**ZOO INTERCHANGE  
REDUCED IMPACTS  
ALTERNATIVE  
MILWAUKEE COUNTY:  
ROAD SAFETY AUDIT**

FINAL REPORT

December, 2011

**Review Stage:** Planning / Preliminary Design Stage (30%)

#### Non-Motorized Road Users Crossing at Free-Flow Loop Ramps

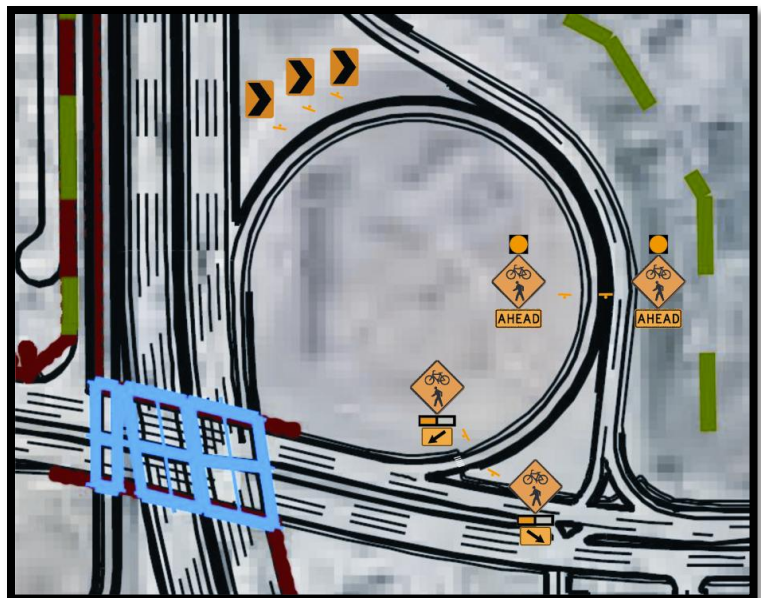
The free-flow loop ramps at both Wisconsin Avenue and North Avenue create a safety issue for non-motorized road users at these locations. Free-flow ramps are designed to reduce delay and increase mobility among motorists. Free flow loop ramps pose a potential risk to non-motorized road users as a result of the lack of traffic control devices available at this type of junction. The extreme speed differentials between pedestrians and motor vehicles are likely to result in serious injuries. Additionally, in many cases, sight distance is also limited as a result of the radius of curvature of the loop ramp.

Alert motorists to the potential for non-motorized road users to be crossing near the ramp terminal by installing warning signs. Consider installing pedestrian crossing warning signs with attached flashing beacons.

1a Agree this has been incorporated into our design. It now includes a free flow right turn lane add and has 45 degree islands.

**Non-Motorized Road Users Crossing Channelized Right-turn Lanes**

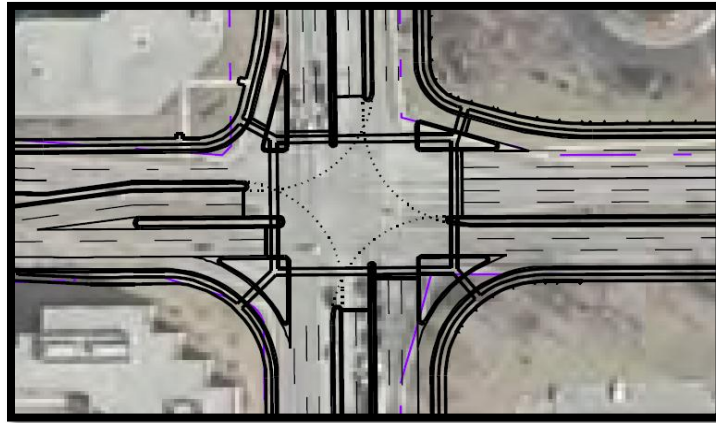
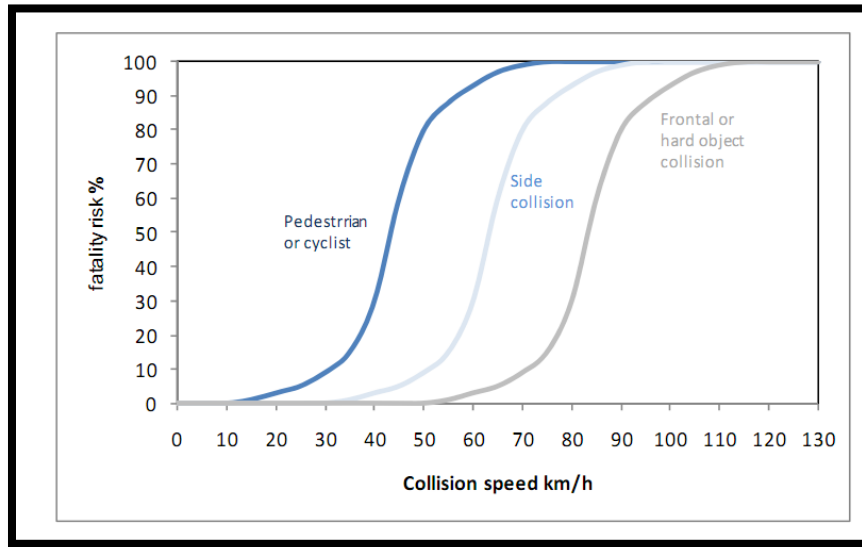
Channelized right-turn lanes, such as those pictured below, can be found throughout the study area. Channelized right-turn lanes decrease delay for motorists by creating a yield controlled intersection allowing for motorists to maintain both speed and momentum when gaps in oncoming traffic present themselves.

This ease-of-use enhancement for motorists creates a potential safety issue for non-motorized road users. Pedestrians and bicyclists attempting to cross the channelized right-turn may not be in many drivers sight-triangle. Additionally, pedestrians may not have the ability to move quickly enough to clear the crosswalk given the higher speeds of vehicles utilizing this lane. Elderly drivers, or those with limited mobility, may have increased difficulty maneuvering their bodies to check for oncoming traffic over their shoulders.

Consider converting all of the 45°/45°/90°-style (see; southwest and southeast islands as shown above) channelization islands to 30°/60°/90°-style (see; northwest and northeast islands as shown above) channelization islands. This adjustment will, while maintaining the efficient yield control, require that drivers reduce their speeds by a larger margin as a result of the change in geometry of the intersection. Additionally, pedestrians and bicyclists will be in a position more visible to motorists.

1b Agree this will be incorporated in preliminary design.

**Bike Lanes on STH-100**

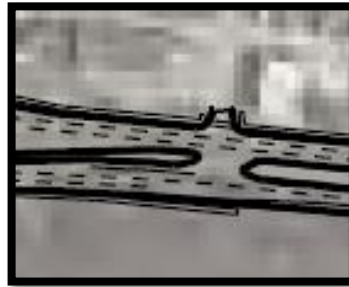
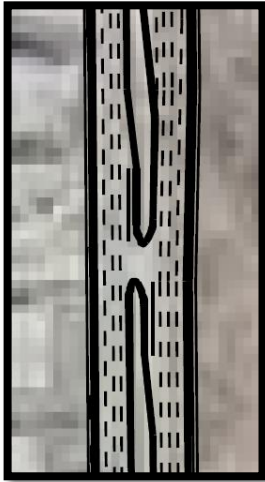
The Reduced Impacts Alternative design proposes a bicycle lane into the plan for STH-100 between IH-94 and Watertown Plank Road. Given the projected traffic volumes and the current 45 M.P.H. speed limit on this roadway, the potential for serious bicycle/motorized vehicle interaction to occur is high.

Consider revising the Reduced Impacts Alternative design to remove the proposed bicycle lanes from STH-100. An alternative may be to create a shared-use path where-in both bicyclists and pedestrians can share a single space set back from the roadway. A shared use path is a safer alternative to and in-road lane as the potential speed differentials between a bicyclist and a pedestrian are likely to result in less-severe injuries. Removing bicyclists from the shoulder will significantly reduce the likelihood of serious bicycle/motor-vehicle interactions occurring.

1c Trans 75 requires inclusion of ped/bike accommodations. The Zoo Interchange Project Team was required to include bike lanes by the Statewide Bicycle & Pedestrian Coordinator.

The FDM states that WisDOT and federal policy, state statutes and administrative codes require include bicycle accommodations on all new construction and reconstruction highway projects. The [Wisconsin's Bicycle Facility Design Handbook](#) states that the WisDOT recognizes the importance of the bicycle as a legitimate mode of transportation and for some people the bicycle is their main or only mode to transportation ( page 1-1). State statute considers bicycles as vehicles and are allowed and expected to be on STH 100.

In the 2011 traffic counts it showed that in a 13 hour period at Watertown Plank Rd. and STH 100, there were a total of 77 bicyclists going through the intersection. STH 100 is an arterial street where major businesses and institutions are often located and are destination points for people, including bicyclists. "Common improvements recommended for arterial streets include: bicycle lanes, wide outside lanes, or shoulders (page 2-5). The Handbook states that bicycle lanes are the preferred bicycle facility on higher volume urban and suburban roadways ( i.e. Arterial streets), (page 3-1) Among the benefits of bicycle lanes are providing adequate width for bicycles which is imperative so that the motorist may pass a bicyclist and stay in the travel lane.

Suggesting that bicyclist use a shared use path through this corridor does not follow design standards. The Handbook points out that "these paths are a complementary system of off-road transportation routes for bicycles and others. They should not substitute for on-road bicycle facilities, but rather supplement a system of on-road bike lanes, wide outside lanes and paved shoulders" (page 4-1) A 2006 bicycle /motor vehicle crash study showed that 29% of urban crashes reported were sidepath/sidewalk crashes.

Figure 5-1 STH-100 at Wisconsin Avenue

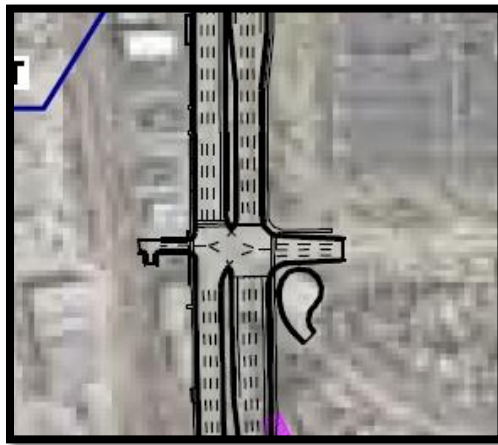
Negatively offset left-turn lanes are present in the Reduced Impacts Alternative Design at the intersection of STH-100 and Wisconsin Avenue as well as at the intersection of Bluemound Road with Glenview. Negatively offset left-turn lanes increase the likelihood of serious angle-type collisions occurring at intersections. The negative offset of opposing left-turn lanes greatly reduces intersection sight distance and may lead to drivers making poor choices in traffic gaps.

Consider reconfiguring these negatively offset left-turn lanes to reflect the safer alternative of positively offset left turn lanes. Positively offset left-turn lanes increase intersection sight distance and will likely reduce the risk of serious angle-type crashes occurring. Protected signal phasing for u-turn movements at the intersection may also be a feasible improvement.

3b These intersections will have protected left turn signal phasing.

**Short Left-Turn Lane, IH-894/USH-45 and Greenfield**

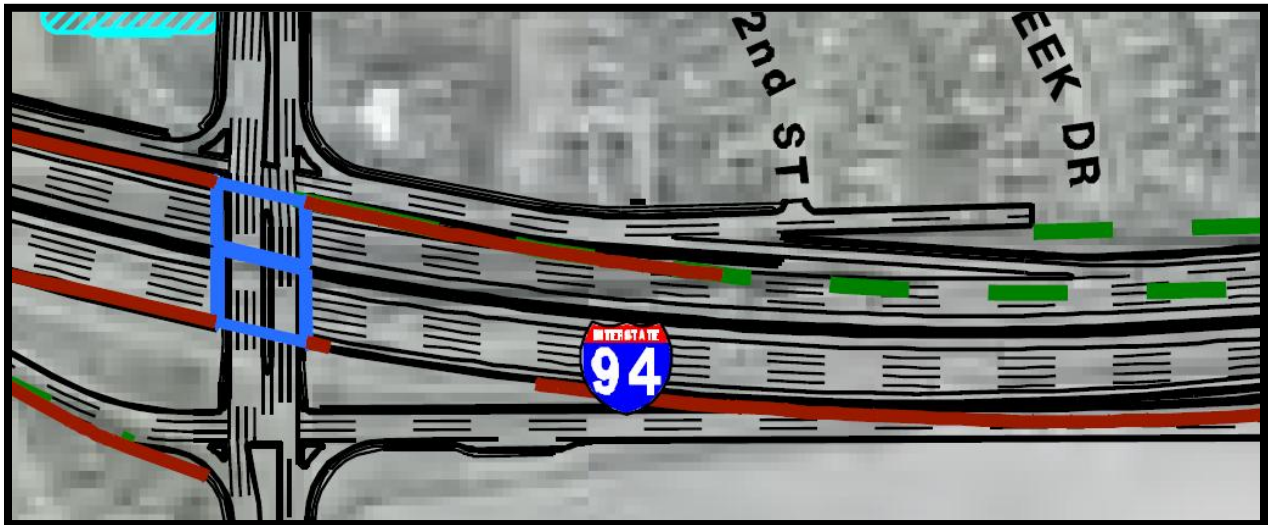
The storage provided for left-turn movements from Greenfield Road to IH-894/USH-45 may be inconsistent with the projected demand volumes for the year 2035. The current design will likely lead to the presence of queues, weaving maneuvers, increased driver frustration and red-light running.

Lengthen the left turn lane to accommodate for more vehicles. This increased storage will reduce the potential for rear-end collisions, and sideswipe crashes by vehicles in neighboring lanes.

7c They have been lengthened in preliminary design.

**IH-94 at 84<sup>th</sup> Street, Weave Section**

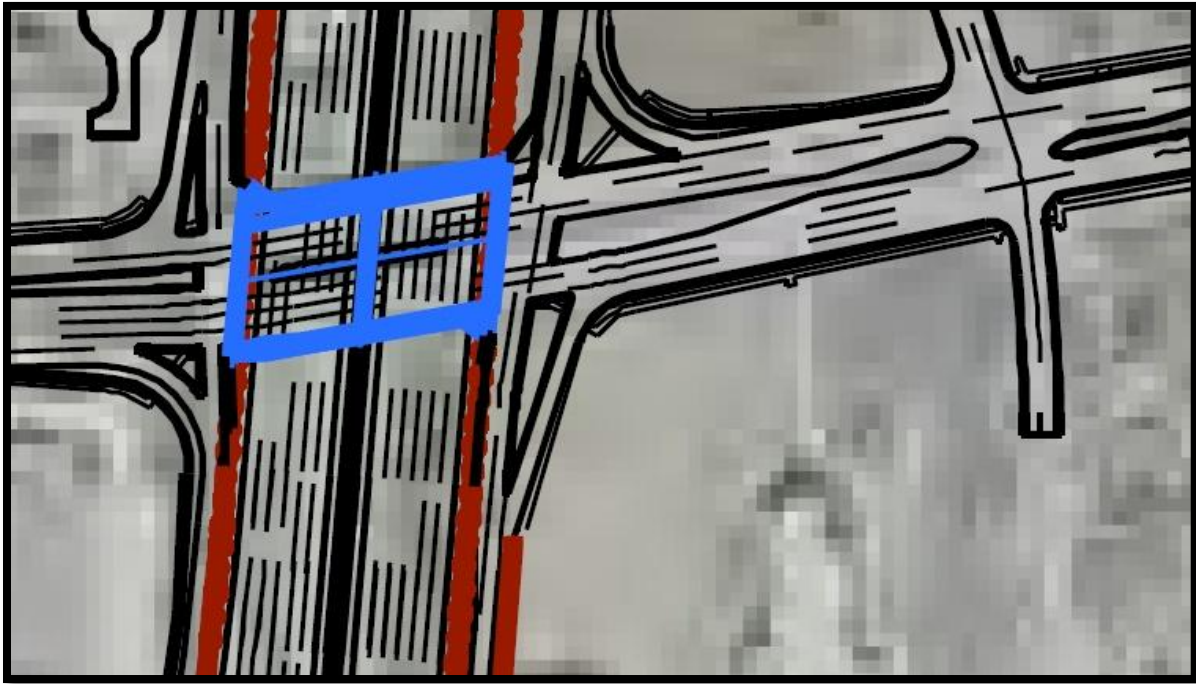
A weave section exists in the Reduced Impacts Alternative Design at the exit-ramp from IH-94 to 84th Street. Motorists intending to head north on 84th Street from westbound IH-94 must merge with traffic from the frontage road and cross two lanes in order to make a right turn.

Review the projected traffic volumes for the frontage road at this location to determine if the provided capacity is required. If the volumes do not support the need for two lanes on the frontage road, consider reducing the frontage road to a single lane. If the projected traffic volumes warrant two lanes on the frontage road, consider moving the exit-ramp to the east to increase the total distance available to drivers to make merging maneuvers.

7d We can discuss with the City of Milwaukee but O'Conner is heavily used during state fair. We will investigate further.

#### Option Lane Exit Signing

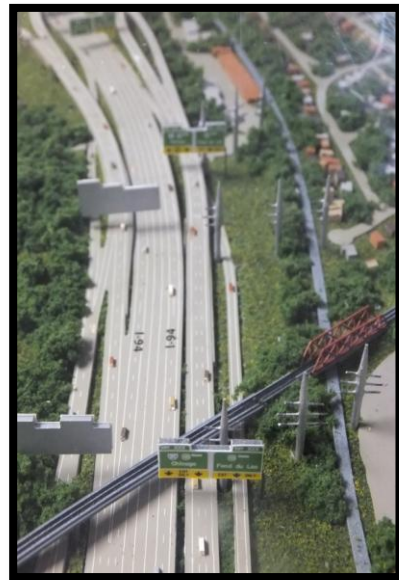
The proposed signing for northbound USH-45 at Watertown Plank Road may not meet MUTCD standards for signing.

Consider verifying that the proposed signing meets current MUTCD standards for guide signs. A standard guide sign for this location may be configured similarly to the sign found below.

8a The guide sign plan has been updated and currently meets MUTCD standards.
